Service Bulletin: AB38

Reference: SB07.07

Affected Machine: **AB38**

Part Affected: Inner boom to transition welding

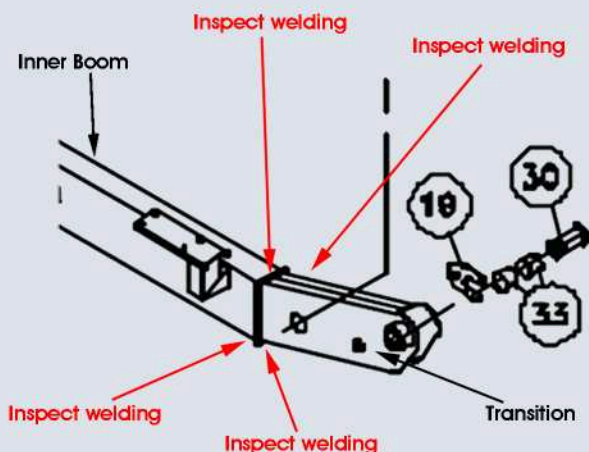
Our Quality team has uncovered a potential problem with welding on the AB38 teleboom, where it meets the transition. As a precautionary measure, all UpRight AB38 lifts should be inspected at the earliest opportunity but within 7 days at the latest.

We advise you to inspect all the welding on the teleboom in the area of the transition as indicated on the diagram below. This is in line with PRE Operation Safety Instructions to be found on Page 5 item 7 of the operators manual which states:

"Inspect the weld on the plate welded to the inner boom and the transition for any signs of: cracks or lifting of the weld from the parent metals. If in doubt, the paint should be removed and inspected with either chemical crack-testing solvents, or with ultra-sound equipment to give the welds."

If you discover any weld issues, please contact the **UpRight Product Support Team**. Please remember to provide us with the machine's complete **Serial Number** and **photographs** of the affected area.
